Re: Technical Corrections Review: Aurora One – Master Plan Amendment
Application Number: DA-2241-08
Case Number: 2020-7004-01

This letter is in response to the City of Aurora's comments dated December 12, 2024. Comment responses are shown in *red*. No redline responses are provided with this submission. We look forward to the City's approval this amendment.

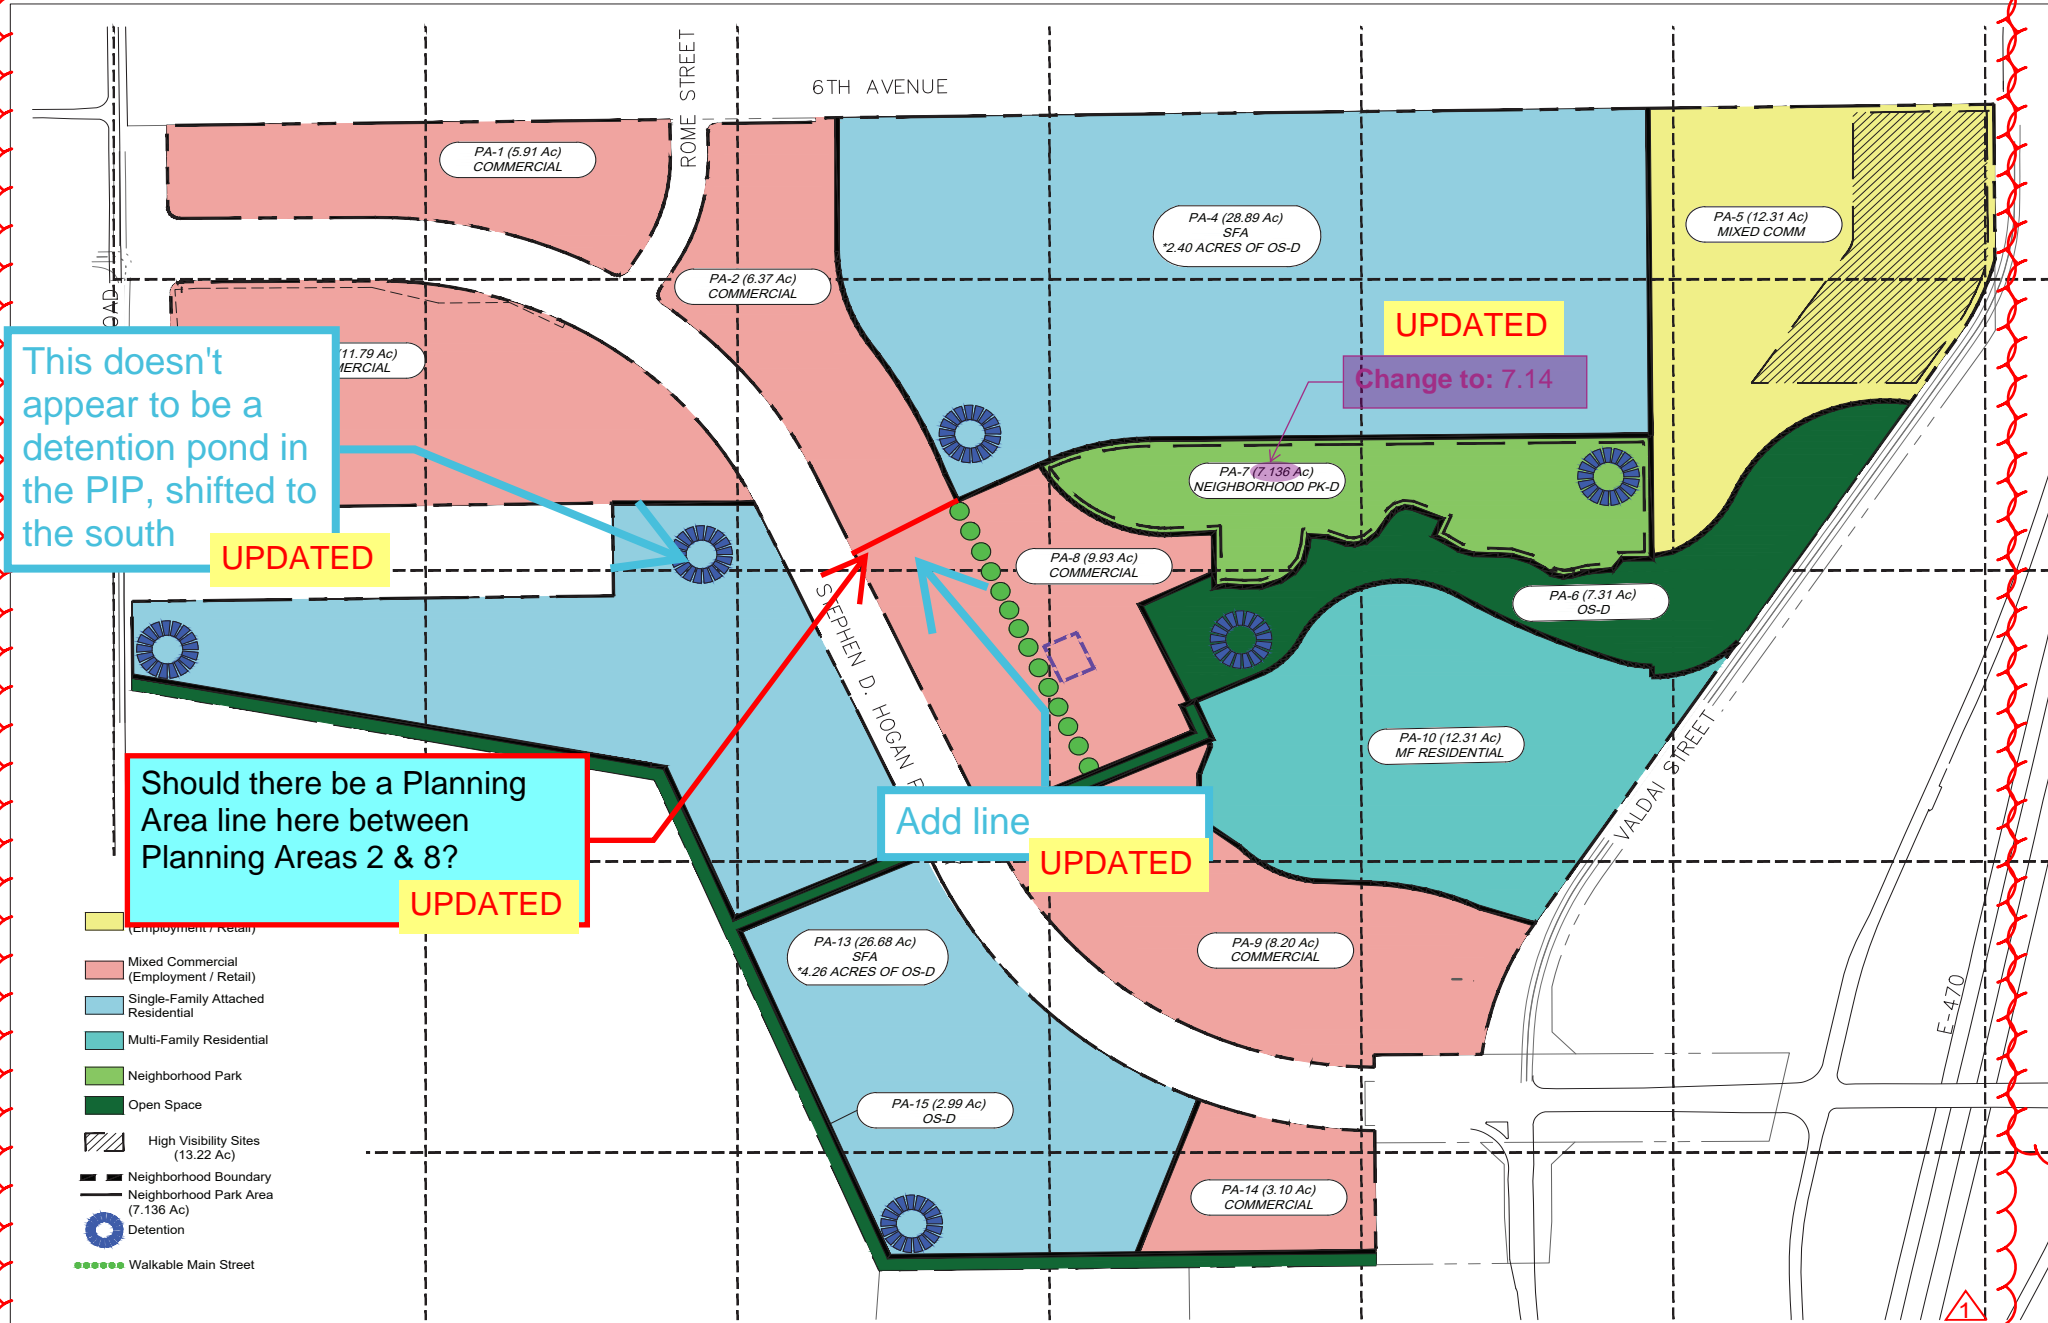
Update this portion of the matrix to reflect the redlines/revisions provided on the previous page (Tab 8-3).

Change to: 24.15

Change to: 17.01

Change to: 26.54

Add: Requirement of 2.45 acres to be met by cash-in-lieu payment.

FORM J AND FORM J NOTES

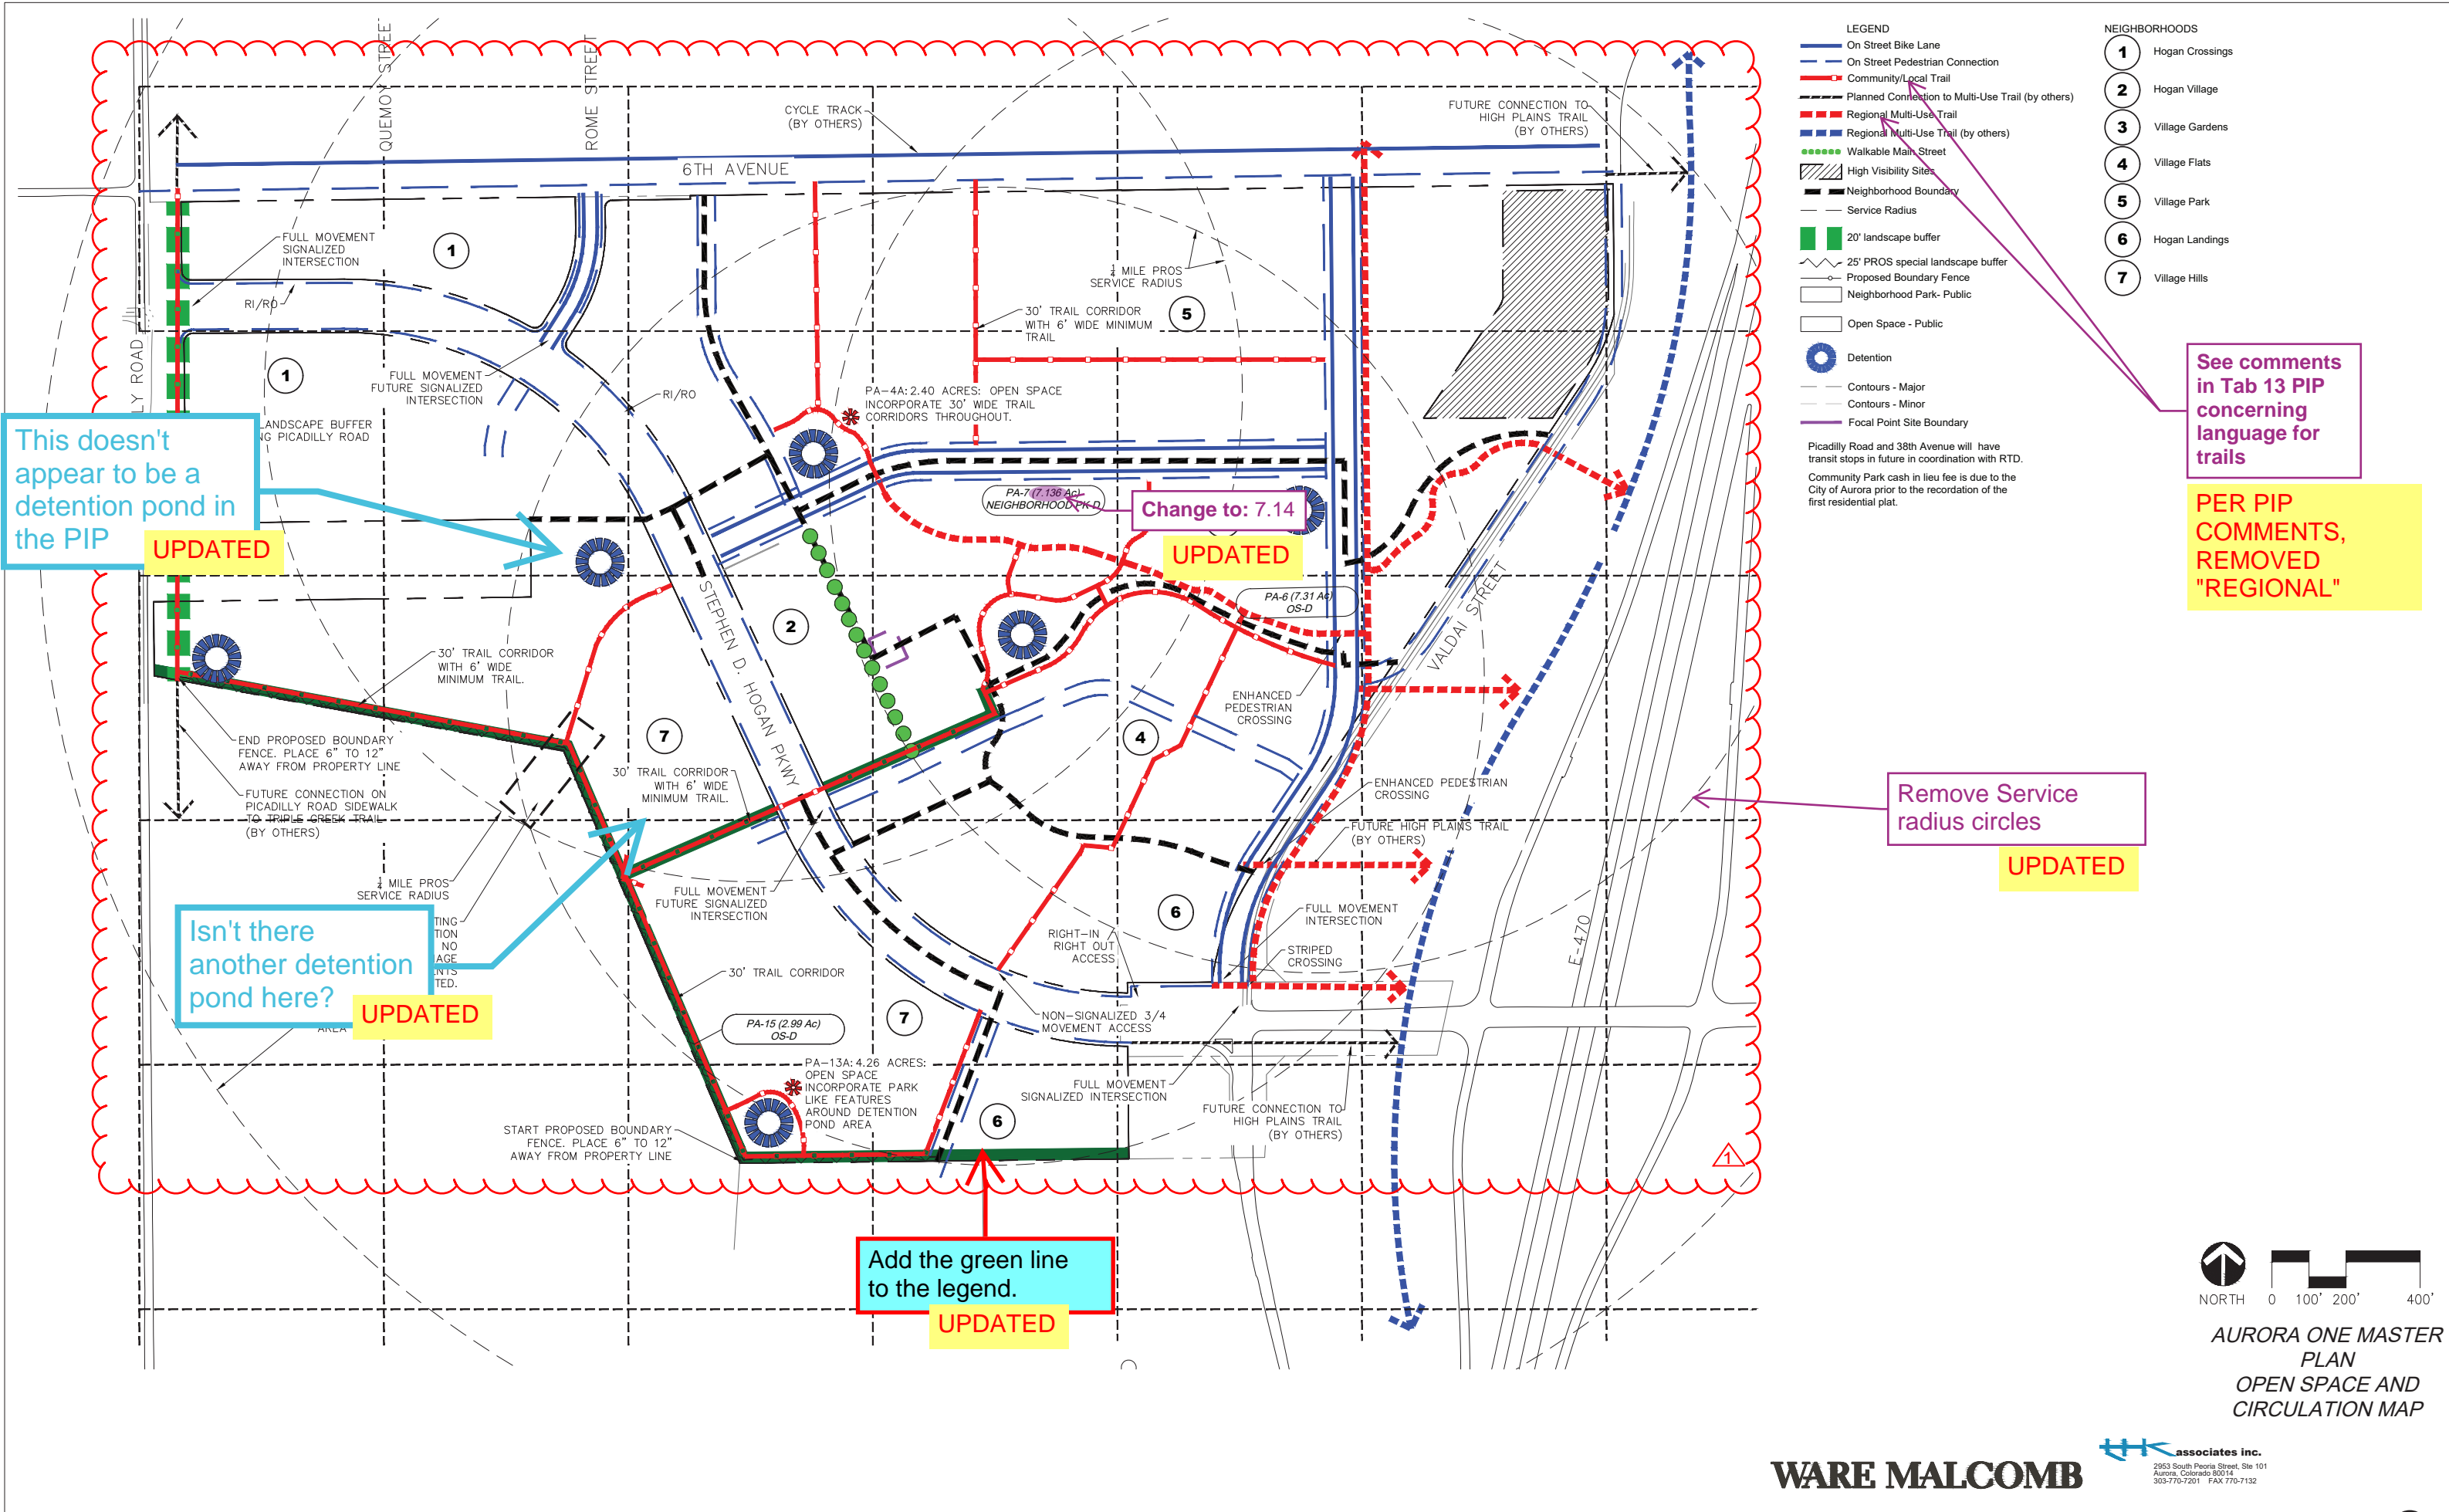
Change to 26.54

Add: Total Cash-in-Lieu of Land Dedication

UPDATED

ADDED

**AURORA ONE
PUBLIC IMPROVEMENT PLAN (PIP)**
A PORTION OF THE NORTH HALF QUARTER OF SECTION 12, TOWNSHIP
4 SOUTH, RANGE 66 WEST OF THE SIXTH PRINCIPAL MERIDIAN, CITY
OF AURORA, COUNTY OF ARAPAHOE, STATE OF COLORADO

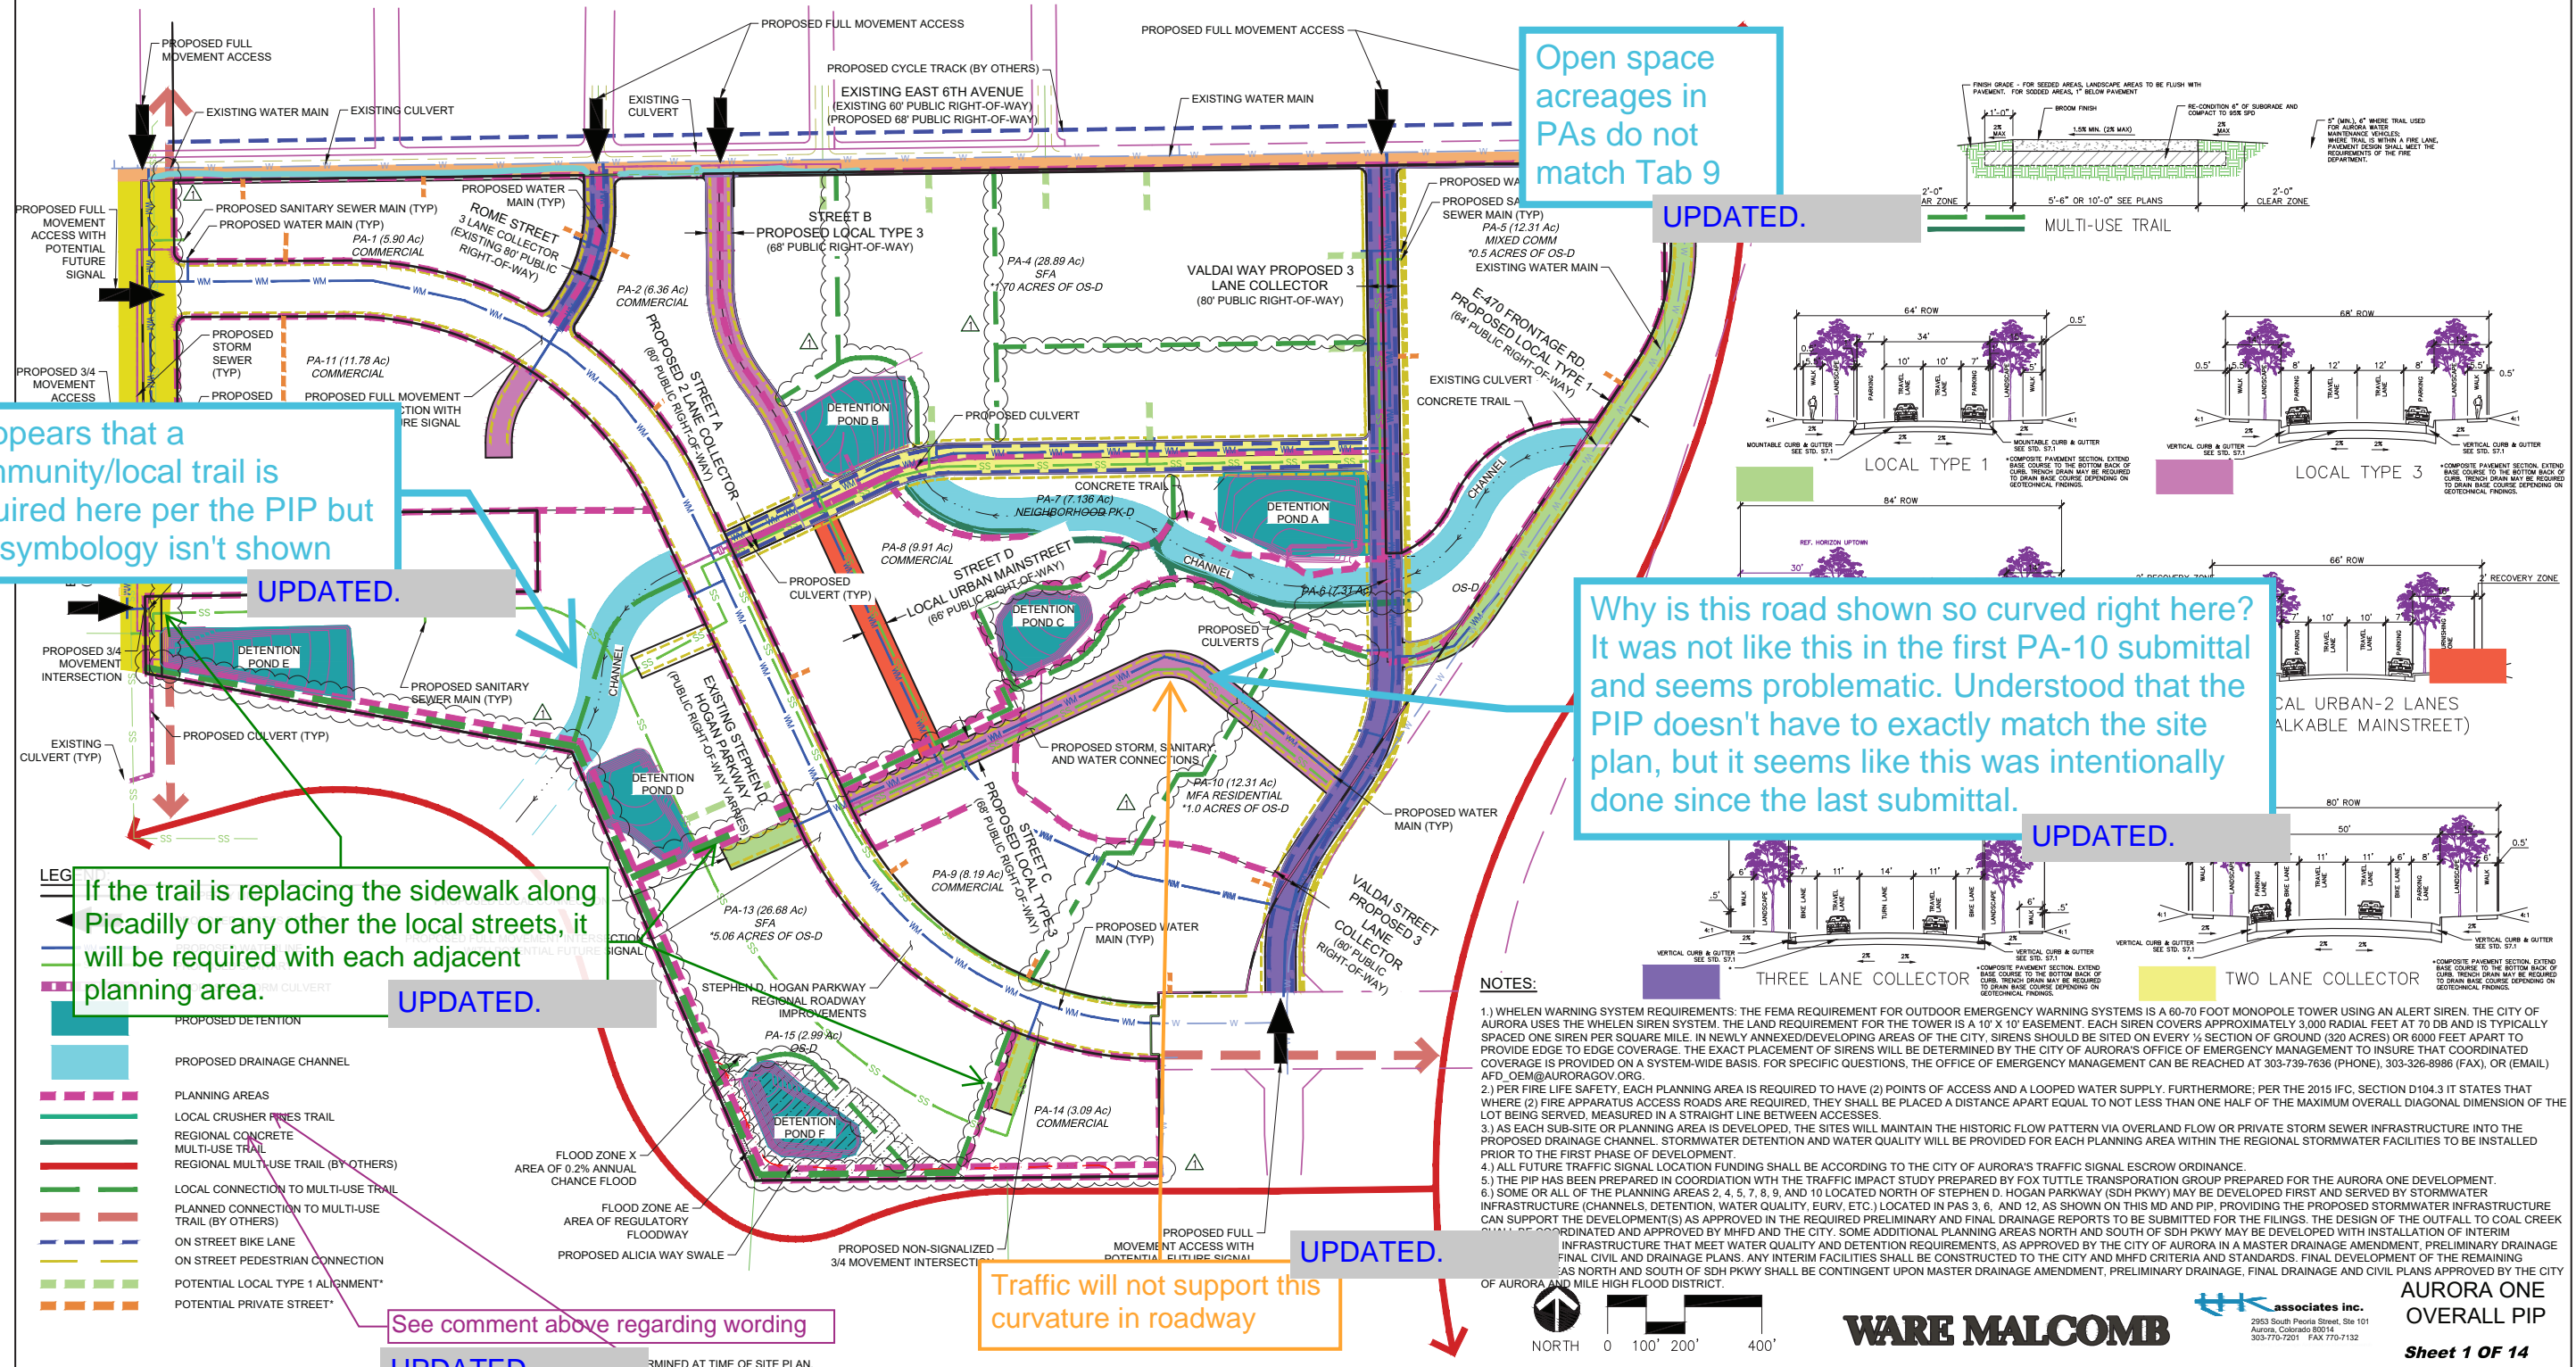
- 1G. The curved road alignment shown in the PIP through PA-10 is problematic and was changed since the last submittal of the Master Plan. Please revise. *The proposed curved road in PA-10 is shown schematically only. The curve has been softened, though final approval of the roadway alignment will occur at the Site Plan stage for PA-10.*

- 4A. Traffic will not support the curvature in the roadway through PA-10 that is shown in the PIP. *The road curvature shown is for reference and has been softened. Further design will follow along with the development and future design of PA-10 and the adjacent planning areas.*
